Re: Docket No. 516 – The United Illuminating Company Application for a Certificate of Environmental Compatibility and Public Need for the Fairfield to Congress Railroad Transmission Line 115-kV Rebuild Project

Enclosed for filing with the Connecticut Siting Council (“Council”) is The United Illuminating Company’s responses to the Council’s May 10, 2023 interrogatories (Set One).

Interrogatory CSC-1

Figure 5. Magnetic field level (mG) at a height of 1 m (3.28 ft) above ground at the Windward apartment building compared to the ICNIRP limit of 2,000 mG.

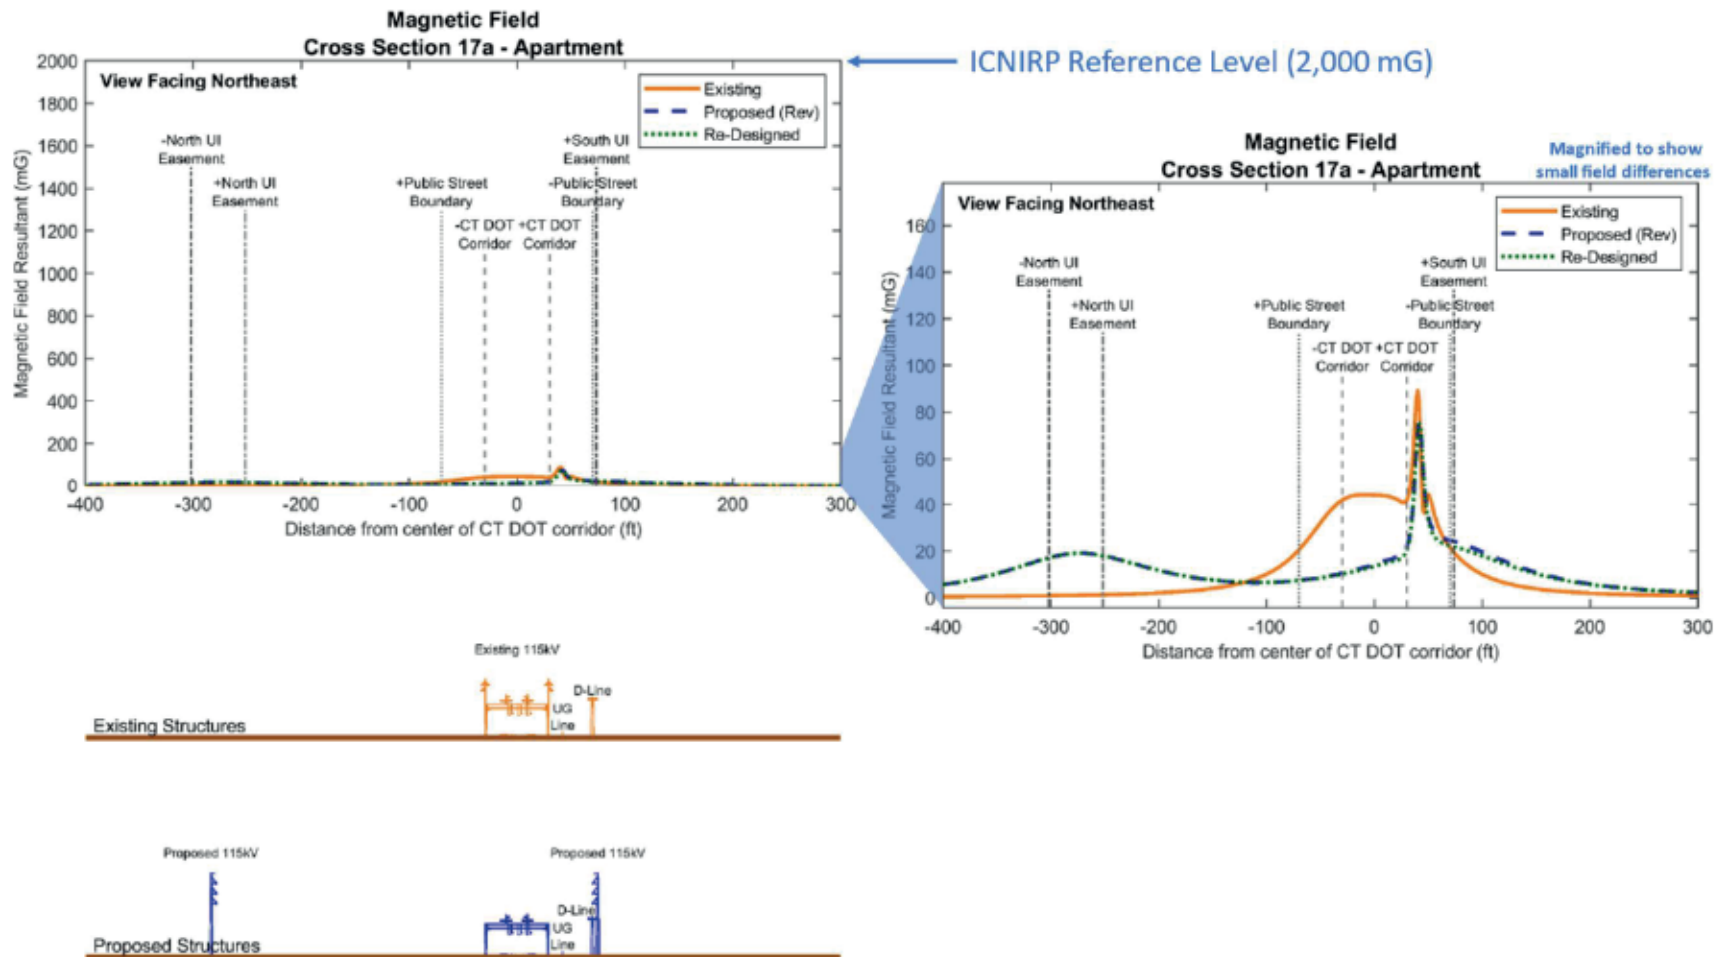
Figure 5 illustrates the result of redesign Option 1, evaluated at a height of 1 m (3.28 ft) above ground, providing a visual summary of the calculated magnetic field, along with representations of the existing and proposed structures, and compares these values to ICNIRP limits on magnetic fields. On the north side of the ROW, there is a negligible change in magnetic-field level as a result of redesign Option 1. At a height of 1 m (3.28 ft) above ground, the dominant source of magnetic fields at the Windward apartment building complex is the existing distribution line and underground Middletown-Norwalk transmission line. Because existing sources are more important to ground-level magnetic-field levels, the increased conductor height in redesign Option 1 has a smaller effect at ground level than at greater heights above ground. At a height of 1 m (3.28 ft) above ground, the redesign results in a reduction in the magnetic field of approximately 9%.

Figure 6. Magnetic-field level at average loading at the Windward apartment building complex in Bridgeport compared to the ICNIRP limit of 2,000 mG.

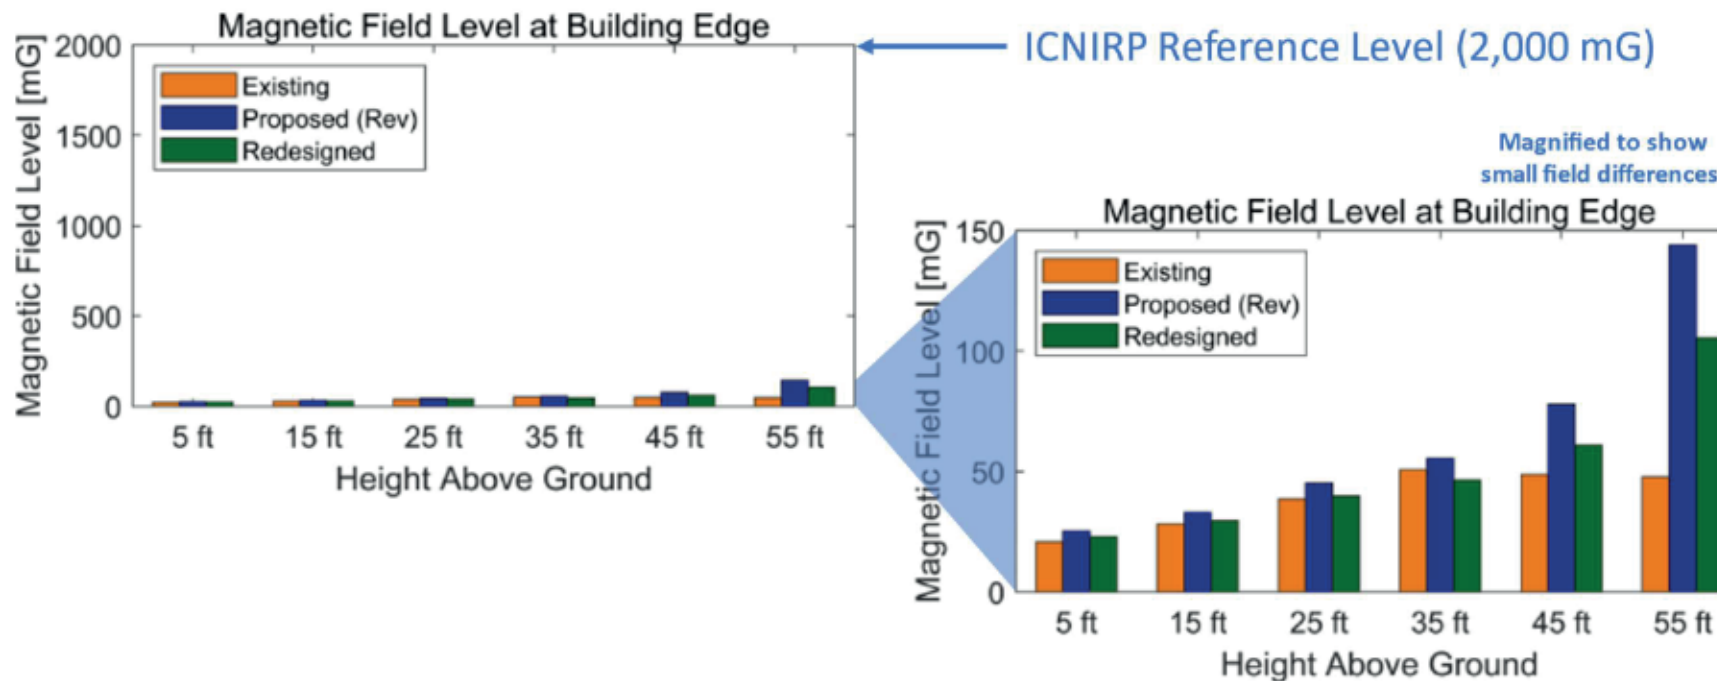
At locations higher above ground, where the existing distribution and underground transmission lines are less dominant, the percentage reduction in magnetic-field level is greater. Figure 6 shows the results of magnetic-field calculations *at the front edge of the building* (closest to the transmission lines) at average loading. The magnetic-field level at every 5 ft above ground is shown for the existing configuration (orange bars), proposed (revised) configuration (blue bars), and redesigned configuration (green bars).

Further analysis of the data in Figure 6 shows that the redesigned configuration results in magnetic-field levels lower than the proposed (revised) configuration at all heights above ground. Up to about 35 ft above ground, the redesigned configuration reduces magnetic-field levels by approximately 9% to 16% compared to the proposed (revised) configuration. The redesigned configuration also results in magnetic-field levels that are 22% lower at 45 ft and 27% lower at the roof than the proposed (revised) configuration. Calculations at peak loading are shown in Figure 7.

Figure 9. Double-circuit structure proposed as part of redesign Option 2.

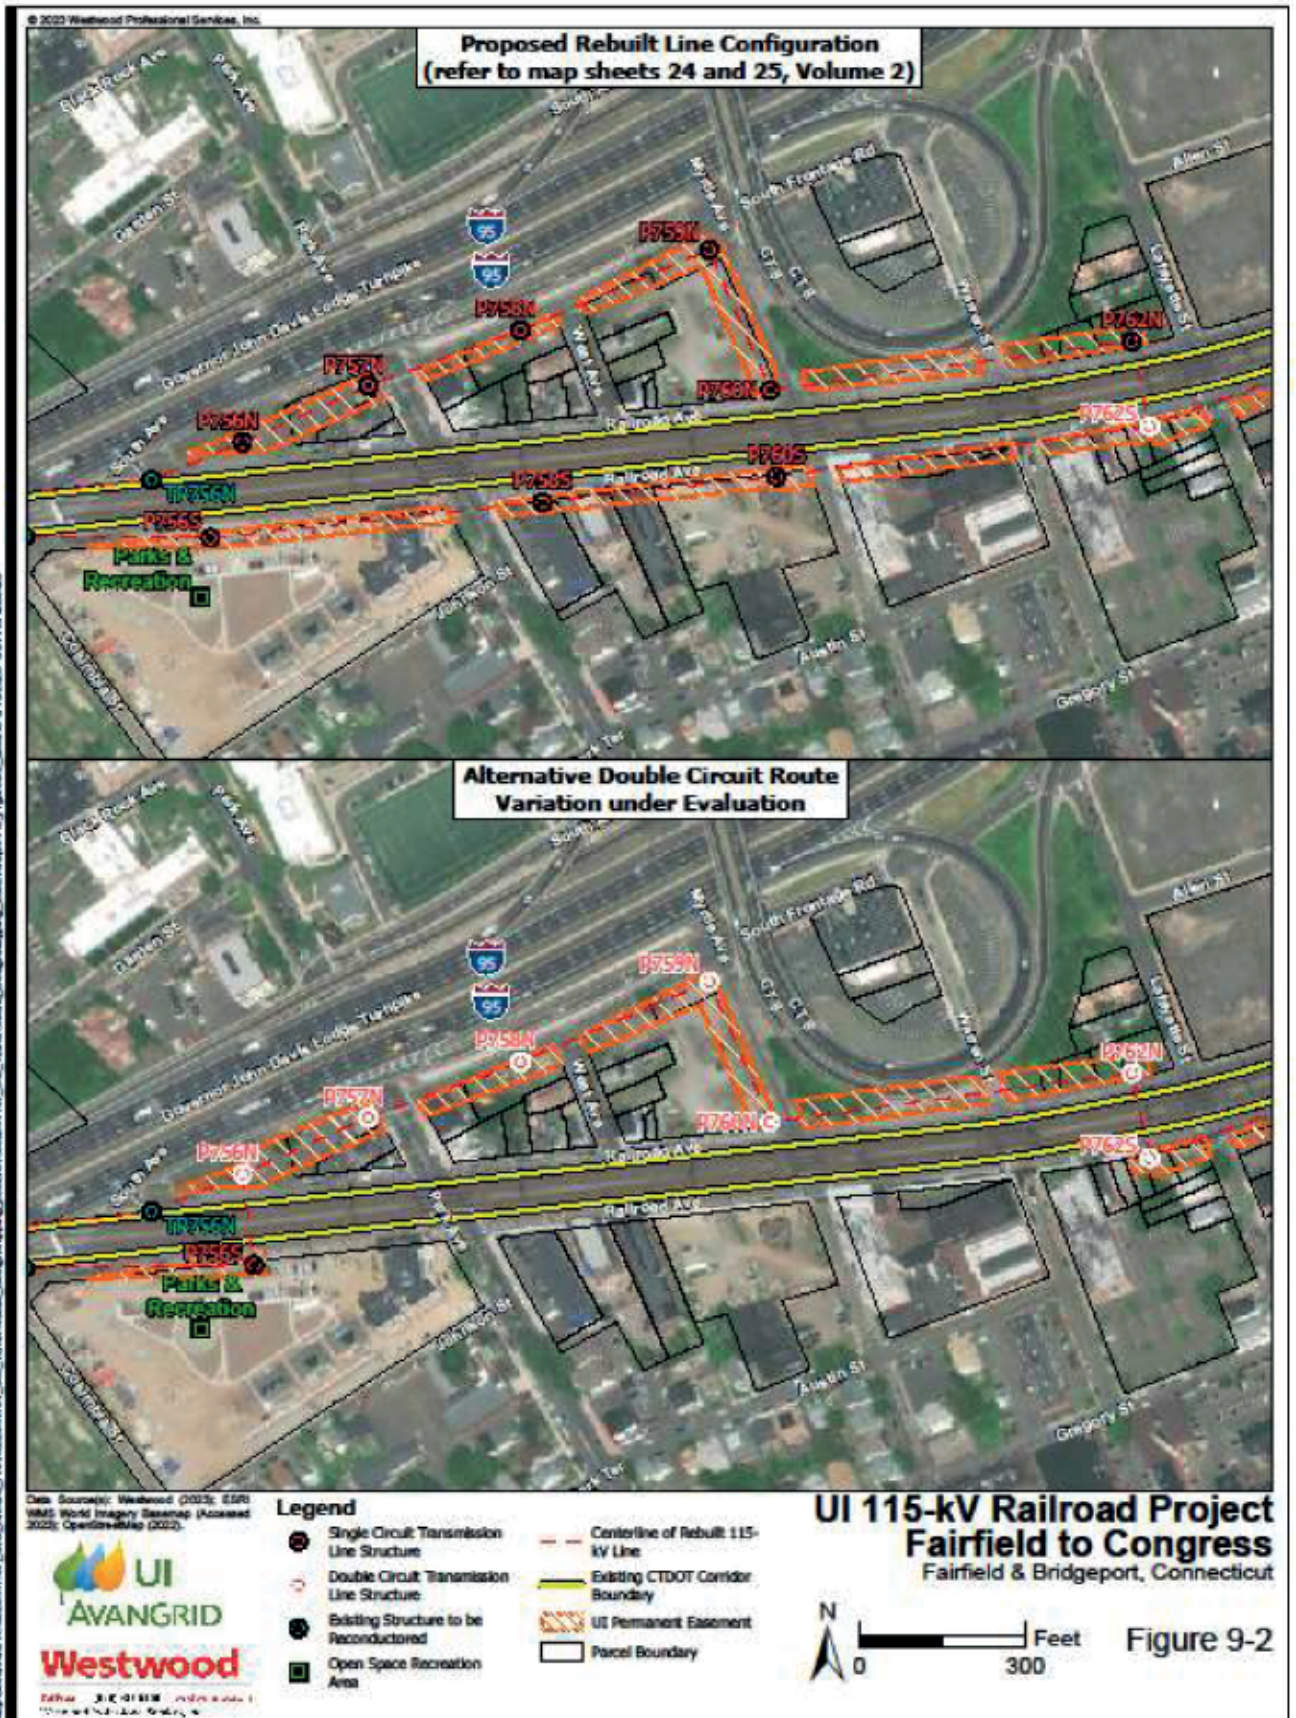
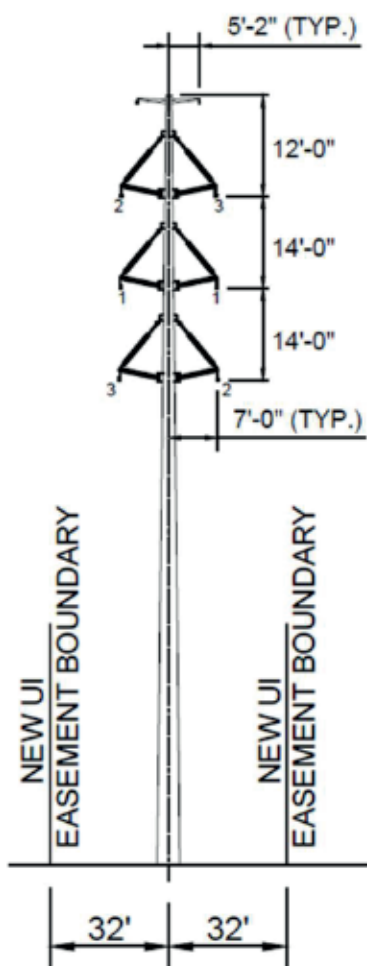
Redesign Option 2 incorporates the CSC BMP's methods of distance, conductor configuration, and optimum phasing to reduce magnetic-field levels. Option 2 moves the transmission line on the south side of the CT DOT corridor to double-circuit monopoles (with optimal phasing) to the northern easement, generally parallel to South Frontage Road.

The double-circuit redesign configuration would require a wider easement north of the CT DOT Corridor—64 ft compared to 50 ft for the proposed (revised) configuration—and would construct Line 1130 (the current line that is on the north side of the MNR), on the north side of the double-circuit structures. Line 91001-1 would be rebuilt on the south side of the double-circuit structures (the current line that is on the south side of the MNR). The minimum conductor height would be 71 ft, with vertical and horizontal phase spacing of 14 ft, and optimal phasing. Figure 9 is an illustration of the proposed double-circuit structure and figure 9-2 shows the plan view of the route.
